**PLANNING COMMISSION
SITE PLAN REVIEW
CASE SUMMARY**

**875 CATAWBA STREET
MIXED-USE APARTMENTS
BET INVESTMENTS**

Subject Property:	875 Catawba Street
TMS#:	08913-05-03 and 08913-05-05
Zoning District:	M-2, -PD (Heavy Industrial within the Planned Development Overlay District)
Council District:	2
Proposal:	Request site plan approval for the construction of a ±113,000 sq. ft., 141-unit, mixed-use apartment building.
Applicant:	BET Investments
Proposed Use:	Apartments/Mixed-Use
Staff Recommendation:	Approval with staff comments.

1 Proposed Site Plan / Ground Floor
1" = 40'-0"

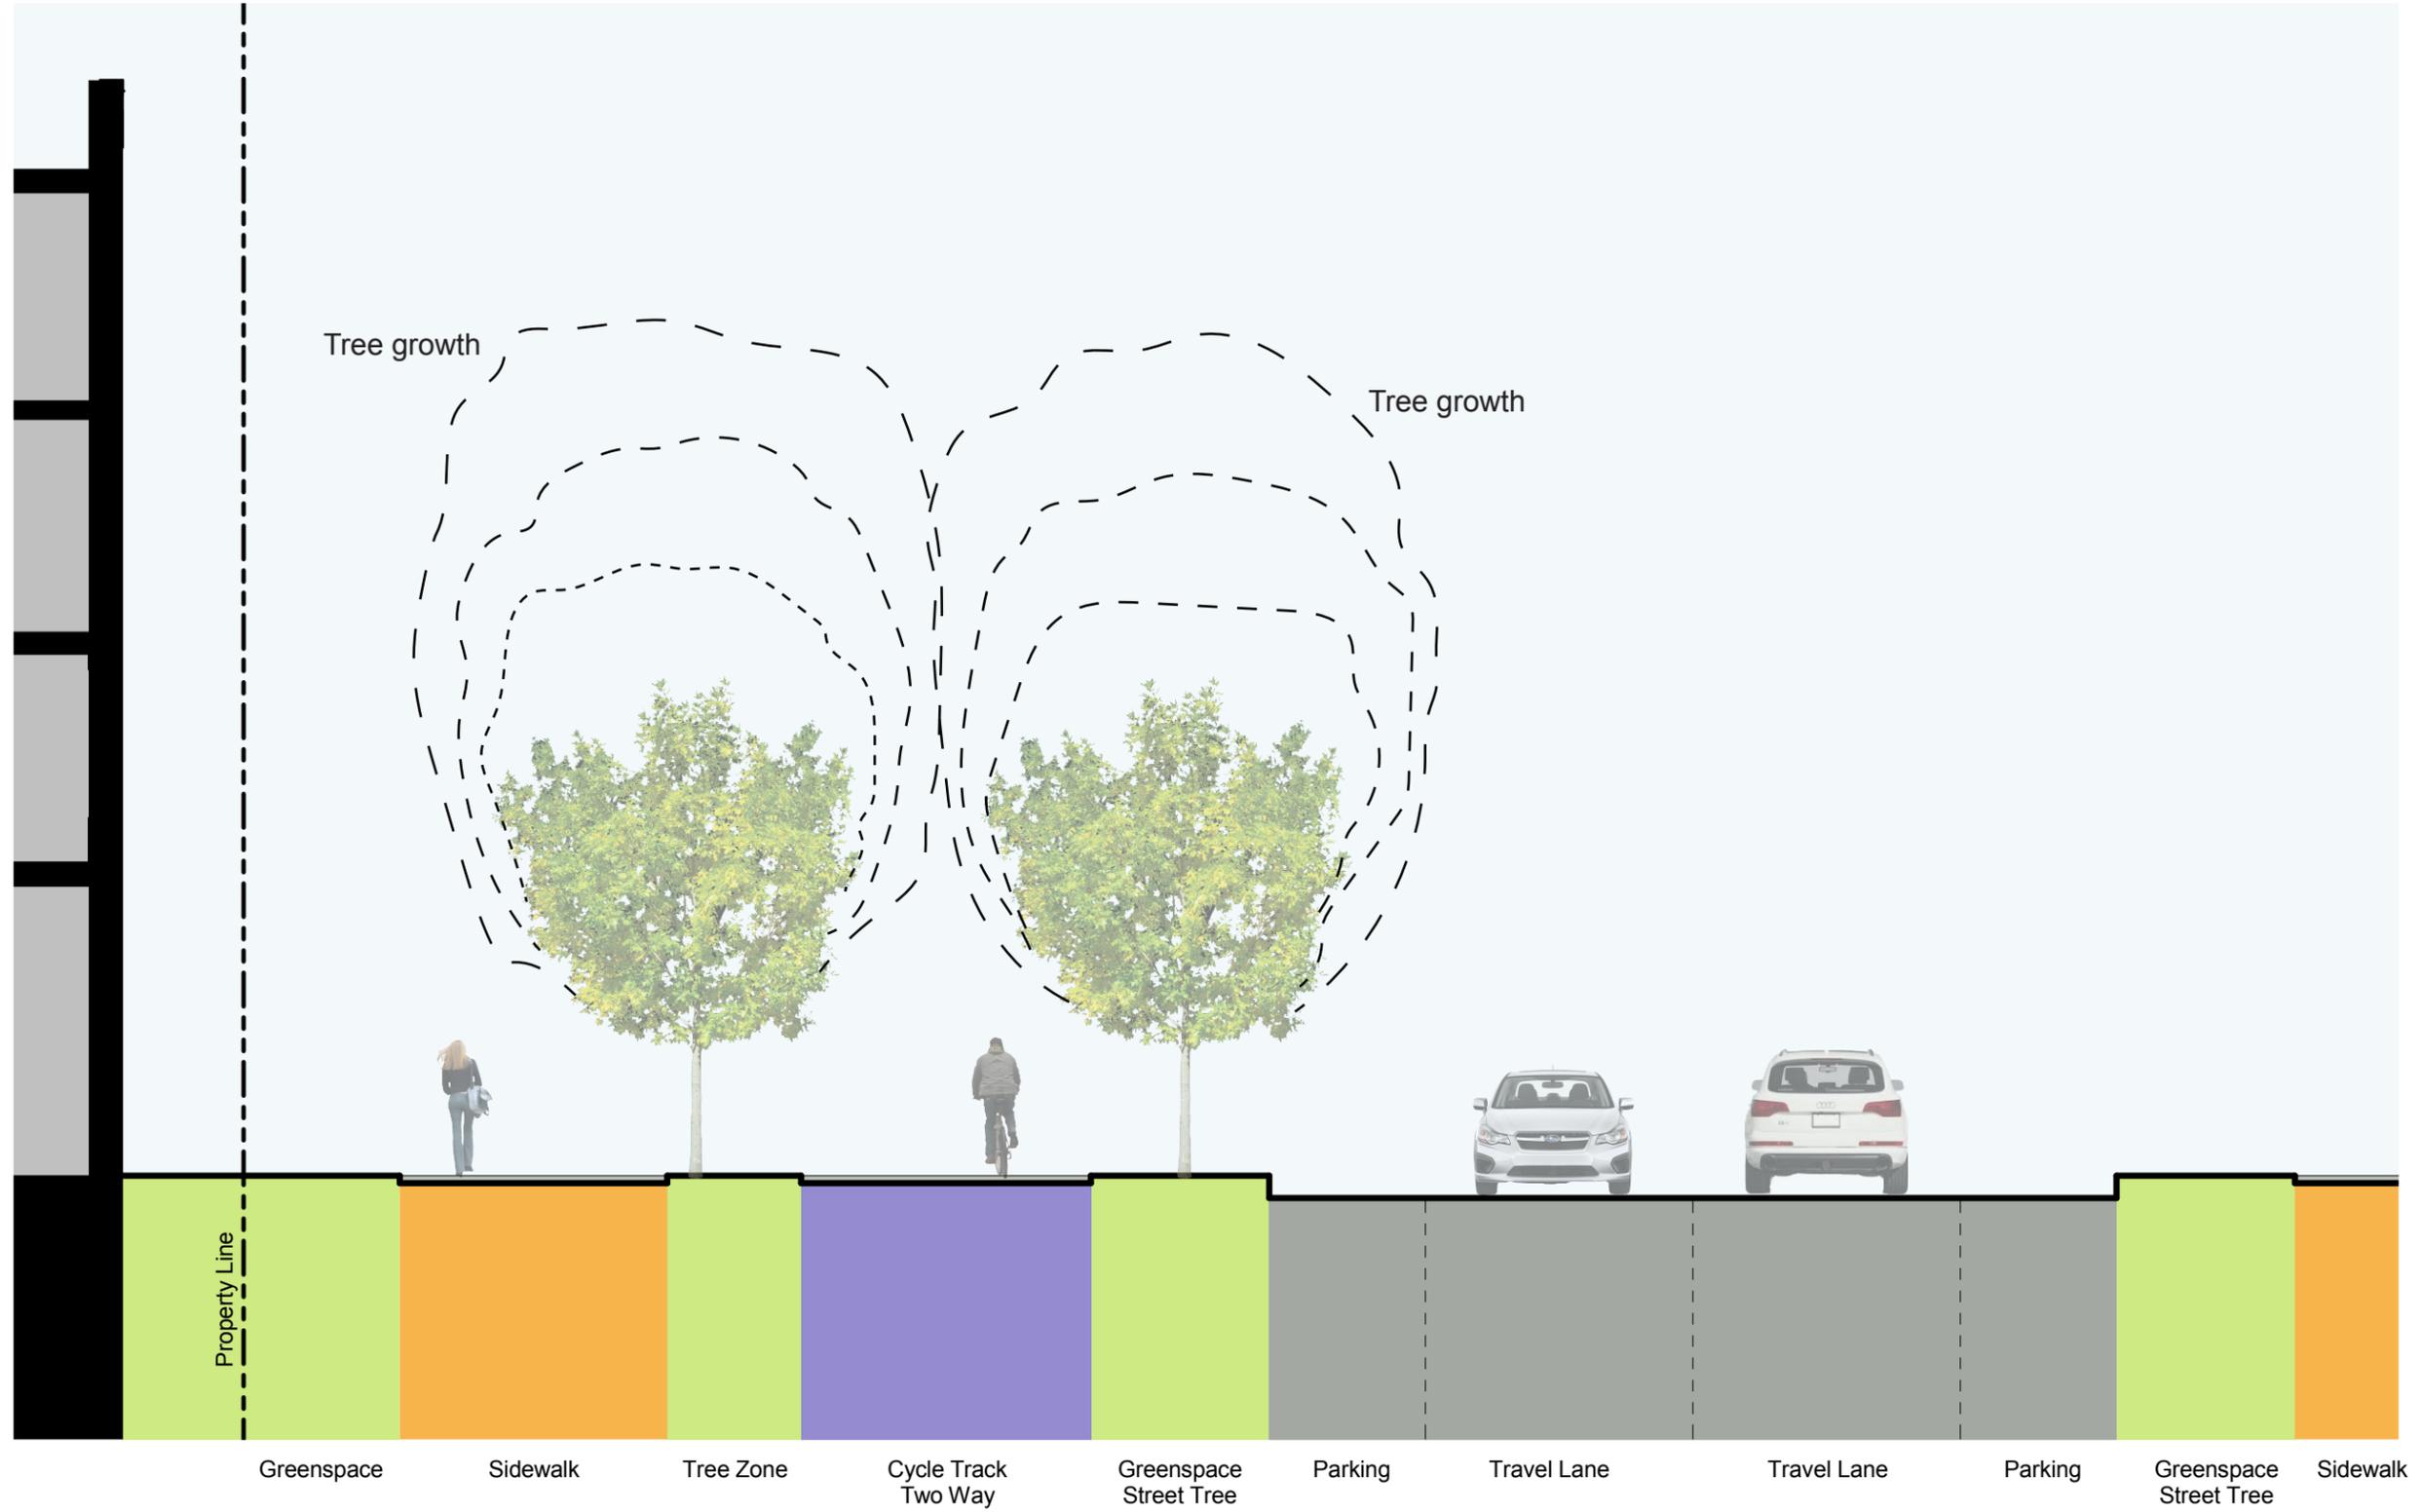
John Fellows, Planning	<p>Recommend approval with conditions:</p> <ol style="list-style-type: none"> 1. Planning is requesting revised drawings addressing the following comments: 2. Lincoln Street – Cross Section continue to work with staff regarding details during the permanent encroachment process. 3. Bike Parking: Interior Bike parking needs to have a clear and direct path from the enclosed space to the cycle track on Lincoln. 4. Bike parking exterior: Planning recommends more than the proposed 20 spaces. 5. Railroad Crossing: Staff has noted in the traffic study that no additional modification to the RR crossing are necessary, however the report focuses on vehicles and not pedestrians and bikes. Given the proximity to USC and venues to the north with 157 units there would be significant
-------------------------------	--

David Brewer, Traffic Engineering	Recommend approval.
Kris Scott, Fire Department	Recommend approval.
Sara Hollar, Forestry	<p>Recommend approval with condition:</p> <ol style="list-style-type: none"> 1. The existing trees in the Lincoln Street right of way cannot be removed. They must be preserved and protected with fencing during the construction to keep all people, equipment and material out of the root zone. If any new landscaping or irrigation is installed in the right of way, it must be approved by Forestry and Beautification and maintained by the adjacent property owner in a manner to not interfere with vehicular and pedestrian traffic.

David Knoche, Parking	Recommend approval.
Robert Sweatt, Street Division	Recommend approval.
John Hooks, Solid Waste	Recommend approval.
Scott Holder, Landscaping	<p>Recommend approval with conditions:</p> <ol style="list-style-type: none"> 1. Detailed landscape plan to be provided. 2. Tree survey to be provided. Credit for existing trees will only be given for existing trees shown on a tree survey. 3. Remaining tree credits to be allocated to the tree fund.
